# Single PMD for Two PHYs – Alternative Solution for i-31

Yasuo Hidaka ([yasuo.hidaka@us.fujitsu.com](mailto:yasuo.hidaka@us.fujitsu.com))  
Fujitsu Laboratories of America, Inc.

January 18-19, 2016

# PHY vs PMD

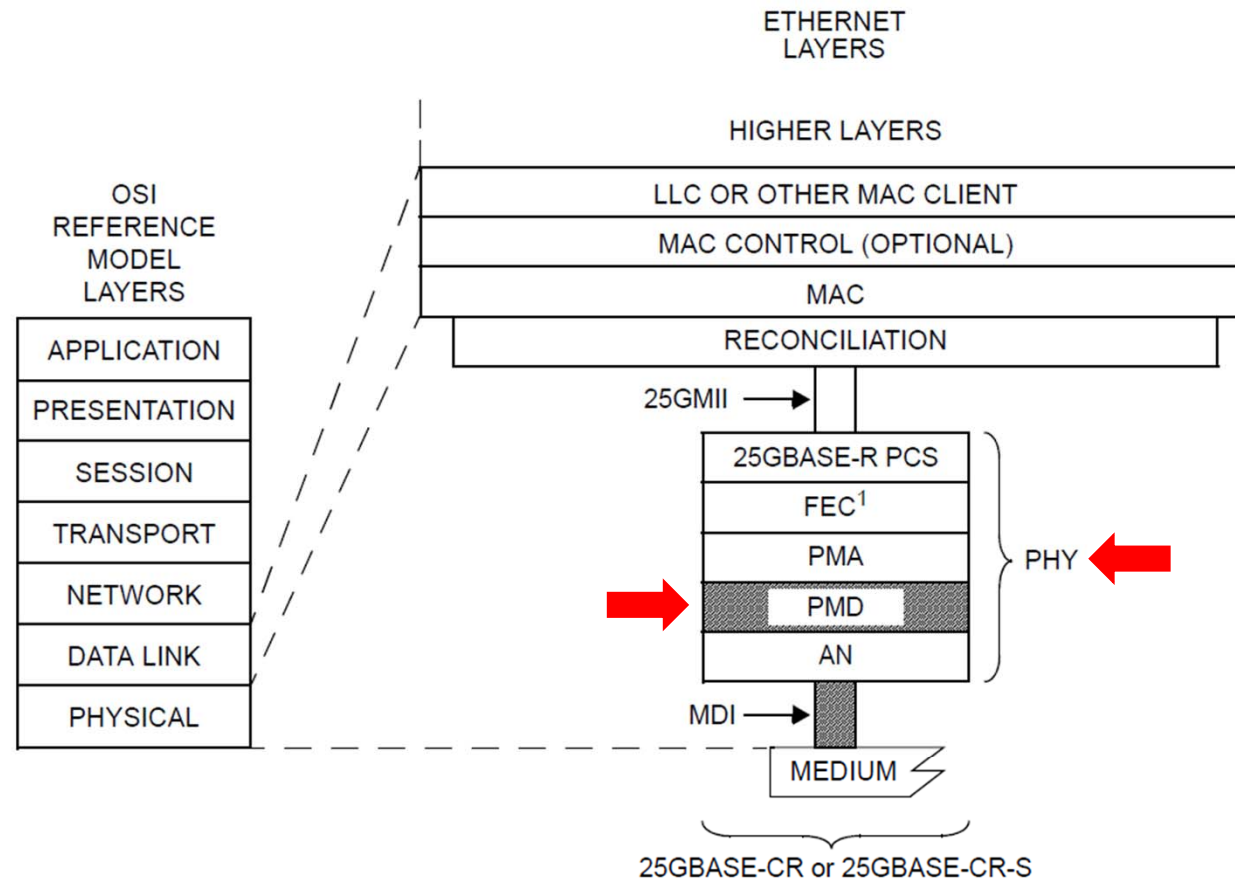
- Defining Two PMDs obscures difference between Two PHYs

- From architectural point of view, defining two almost same PMDs in the protocol stack is a poor practice of abstraction

- By merging Two PMDs to Single PMD, we can clarify the difference between Two PHYs
  - FEC-mode resolution using AN remains same and is still complicated
